HISTORIC AND DESIGN REVIEW COMMISSION

HDRC CASE NO: 2022-453
ADDRESS: 228 BARRERA
LEGAL DESCRIPTION: NCB 717 BLK 14 LOT 7
ZONING: IDZ, H
CITY COUNCIL DIST.: 1
DISTRICT: Lavaca Historic District
APPLICANT: NICHOLAS MELDE/Architexas
OWNER: JS&WS HOLDINGS LLC
TYPE OF WORK: Construction of a 2-story residential structure
APPLICATION RECEIVED: August 19, 2022
60-DAY REVIEW: Not applicable due to City Council Emergency Orders
CASE MANAGER: Rachel Rettaliata

REQUEST:

The applicant is requesting conceptual approval to construct a new 2-story, single-family residence totaling approximately 1,640 square feet with an attached carport.

EAST ELEVATION
SCALE: 1/4" = 1'-0"

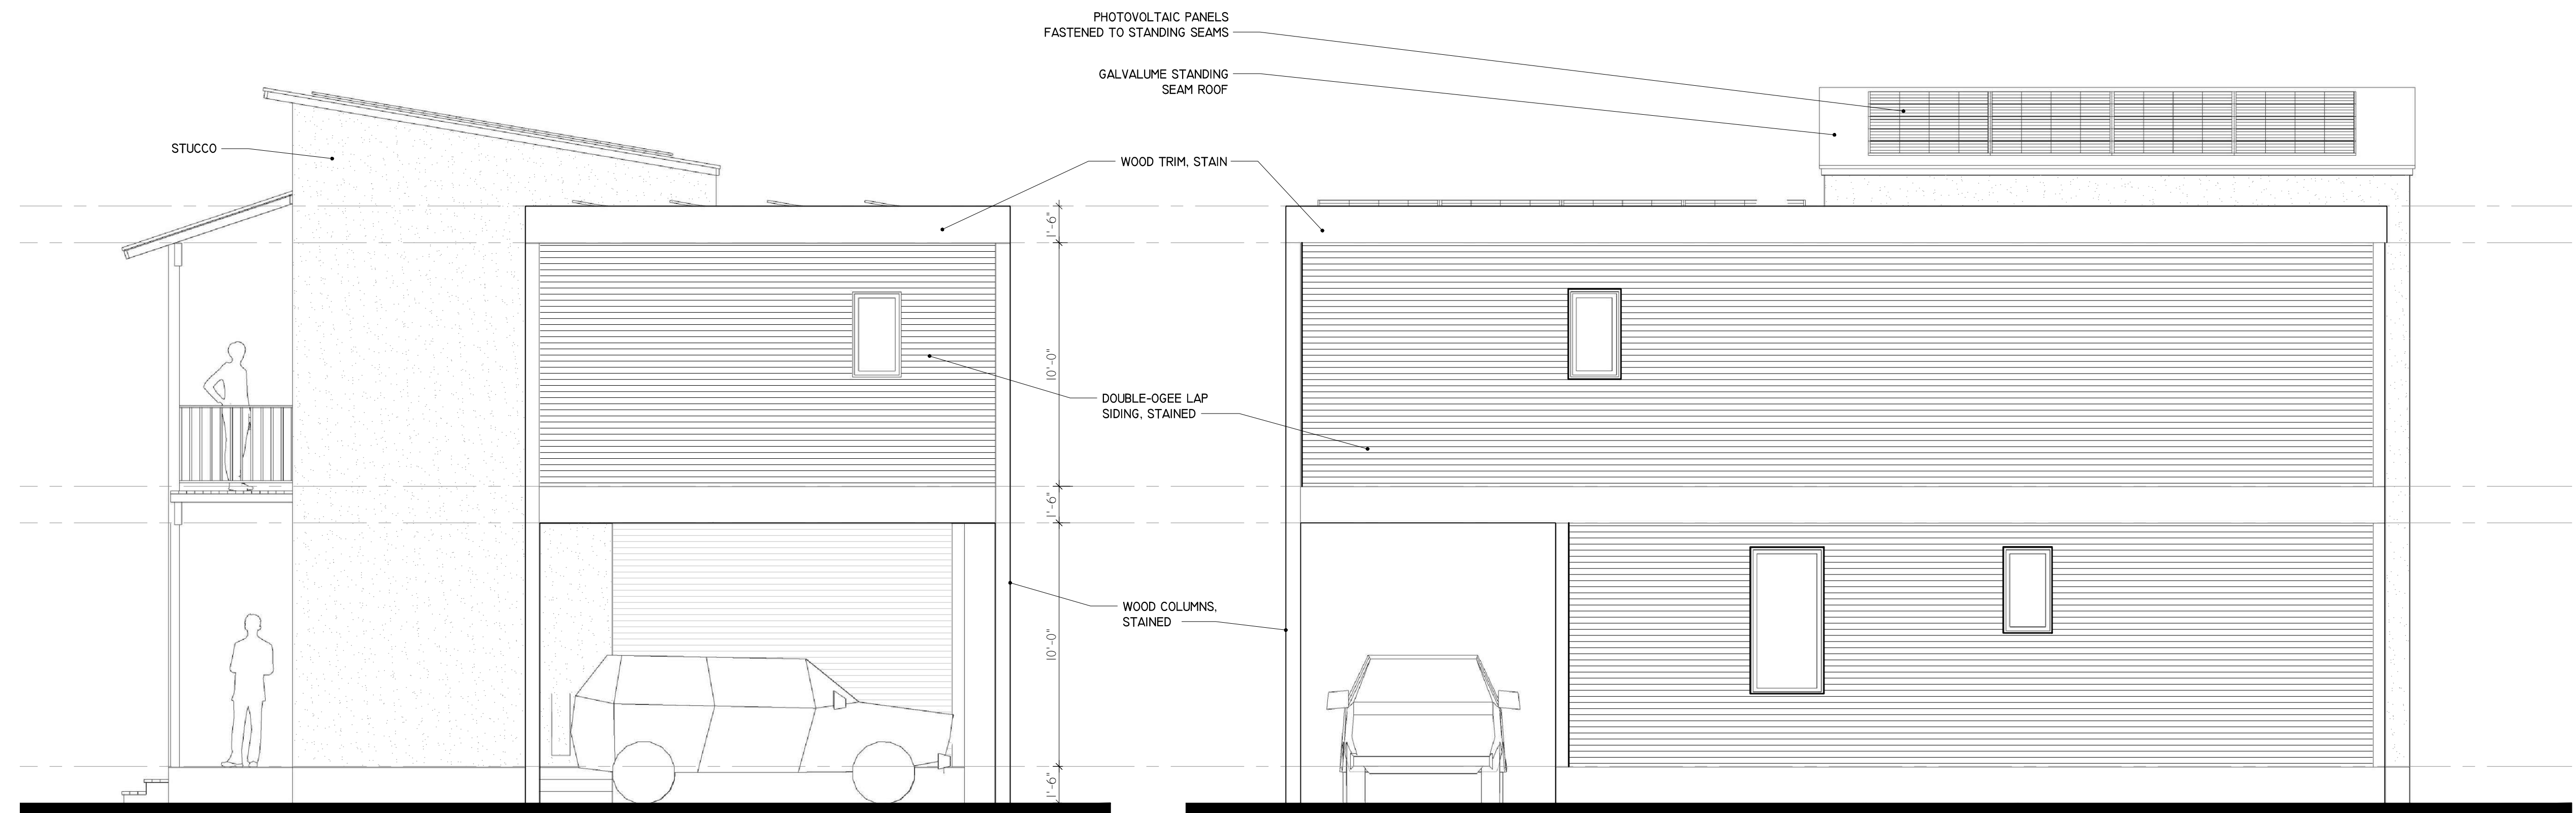
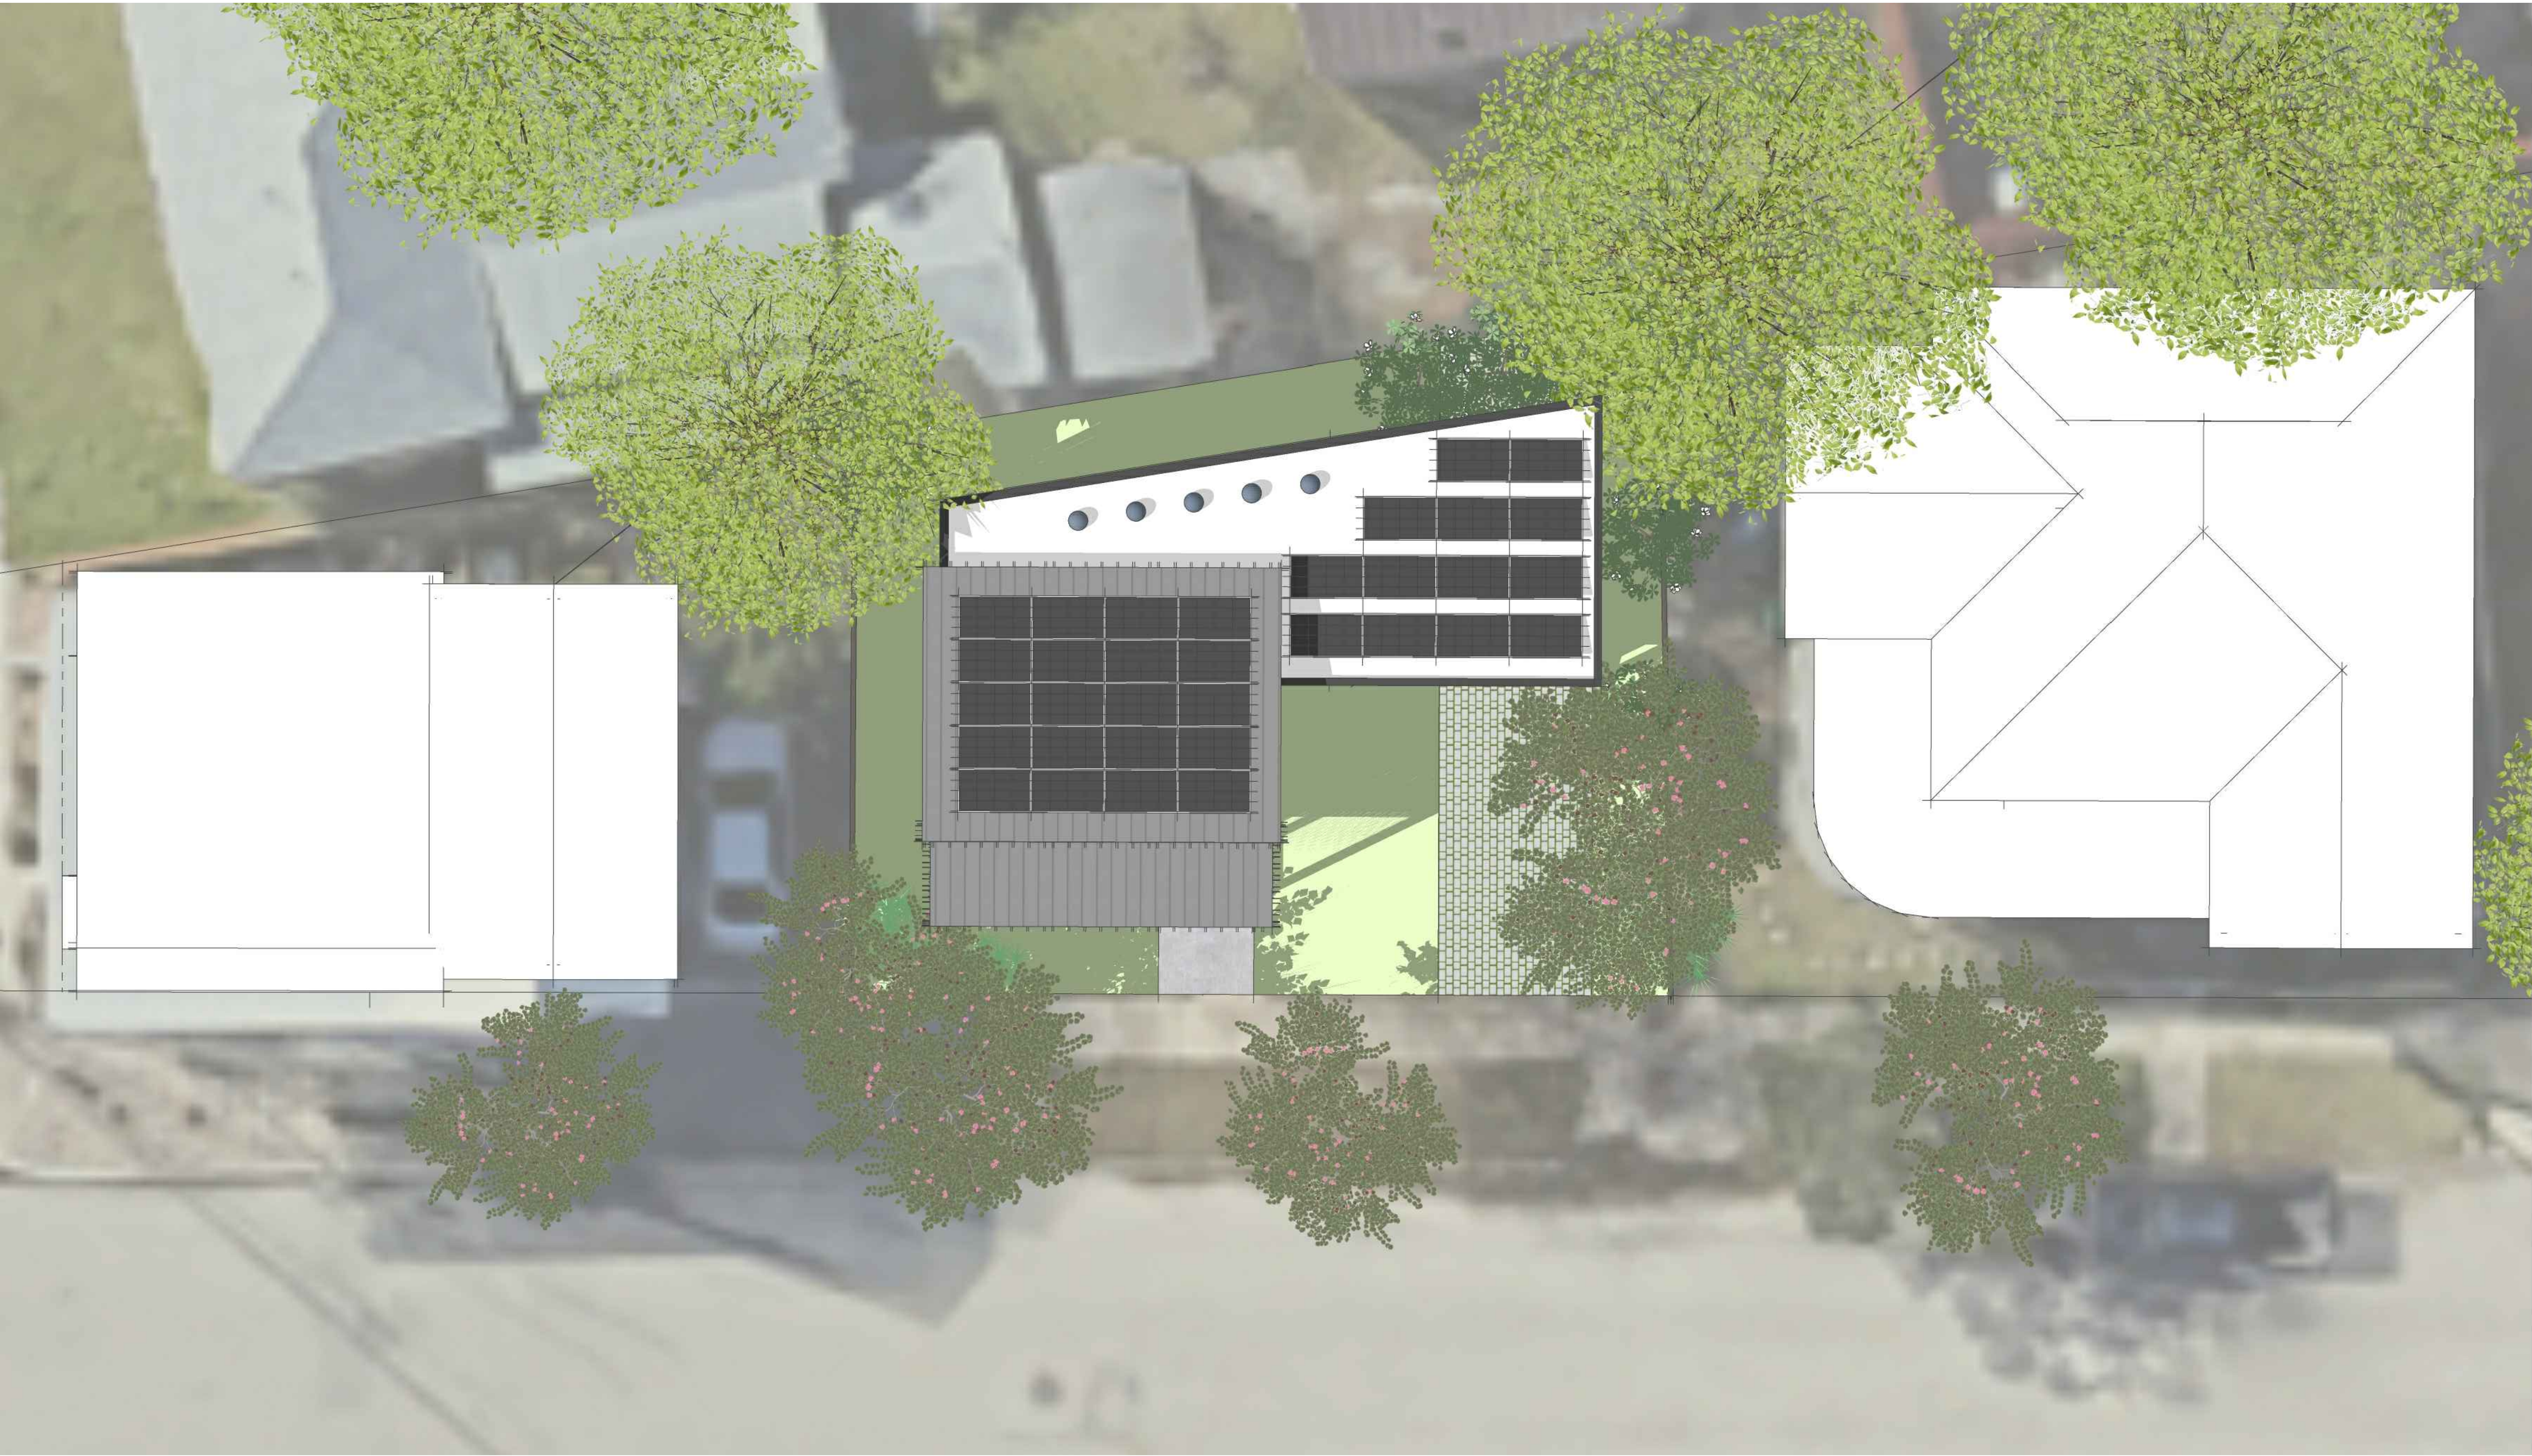
- e. SCALE AND MASSING – The applicant has proposed to construct a 2-story residential structure with a second-story extension to accommodate a row of clerestory windows. According to Guideline 2.A.i for New Construction, new structures should feature a height and massing that is similar to historic structures in the vicinity. In residential districts, the height and scale of new construction should not exceed that of the majority of historic buildings by more than one story. The block within the Lavaca Historic District features 1-story and 2-story historic structures and 2-story units of new construction. The block to the east of Indianola features 2-story infill. The applicant has submitted foundation heights of 1'-6." Staff finds that the proposed scale and massing of the structure appears generally appropriate.

- f. ROOF FORM – The applicant has proposed a shed roof and a flat roof form. According to Guideline 2.B.i

for New Construction, new construction should feature roof forms that are consistent with those predominantly found on the block. The adjacent structures on Barrera feature front gable, cross gable, pyramidal, hip, flat, and shed roof forms. The neighboring contemporary structure features a shed roof form paired with a front gable roof form. Staff finds the proposal consistent with the Guidelines.

- h. MATERIALS AND TEXTURES – The applicant has proposed to construct the residence with 3-coat, color-integrated stucco cladding and wood lap siding with a double-ogee waterfall profile with a semi-transparent stain, a galvalume standing seam metal shed roof on the primary volume and TPO low-sloped roofing over the secondary volume with an 8-inch-tall parapet, aluminum-clad wood windows and doors, wood front porch posts and framing, and a metal balcony railing. Guideline 3.A.i for New Construction stipulates that new construction should use materials that complement the type, color, and texture of materials traditionally found in the district. Materials should not be so dissimilar as to distract from the historic interpretation of the district. For example, corrugated metal siding would not be appropriate for a new structure in a district comprised of homes with wood siding. Consider using traditional materials, such as wood siding, in a new way to provide visual interest in new construction while still ensuring compatibility. Staff finds the proposed materials to be generally appropriate.

- i. WINDOW MATERIALS – The applicant has proposed to install aluminum-clad wood fixed, transom, and one-over-one windows. The aluminum-clad wood windows should feature an inset of two (2) inches within facades and should feature profiles that are found historically within the immediate vicinity. An alternative window material may be proposed, provided that the window features meeting rails that are no taller than 1.25” and stiles no wider than 2.25”. White manufacturer’s color is not allowed, and color selection must be presented to staff. There should be a minimum of two inches in depth between the front face of the window trim and the front face of the top window sash. This must be accomplished by recessing the window sufficiently within the opening or with the installation of additional window trim to add thickness. Window trim must feature traditional dimensions and an architecturally appropriate sill detail. Window track components must be painted to match the window trim or be concealed by a wood window screen set within the opening. Faux divided lites are not permitted. Staff finds that all windows installed should feature traditional operations and that the applicant should submit product specifications for review prior to returning to the HDRC.

- l. CARPORT – The applicant has proposed to construct an attached front-facing, single-bay carport on the west side of the property. Guideline 5.A.i for New Construction states that new garages and outbuildings should be designed to be visually subordinate to the principal historic structure in terms of their height, massing, and form. The carport is proposed as a distinct volume that is set back 8’-10” from the front façade wall plane of the main volume. According to Guideline 5.B.i for New Construction, the predominant garage orientation found along the block should be matched. Do not introduce front-loaded garages or garages attached to the primary structure on blocks where rear or alley-loaded garages were

- i. That the applicant submits window specifications to staff for review prior to returning to the HDRC based on finding i. Wood or aluminum-clad wood windows are recommended. Windows should feature traditional operations, an inset of two (2) inches within facades, and profiles that are found historically within the immediate vicinity. White manufacturer’s color is not allowed, and color selection must be presented to staff. There should be a minimum of two inches in depth between the front face of the window trim and the front face of the top window sash. This must be accomplished by recessing the window sufficiently within the opening or with the installation of additional window trim to add thickness. Window trim must feature traditional dimensions and architecturally appropriate sill detail. Window track components must be painted to match the window trim or concealed by a wood window screen set within the opening.
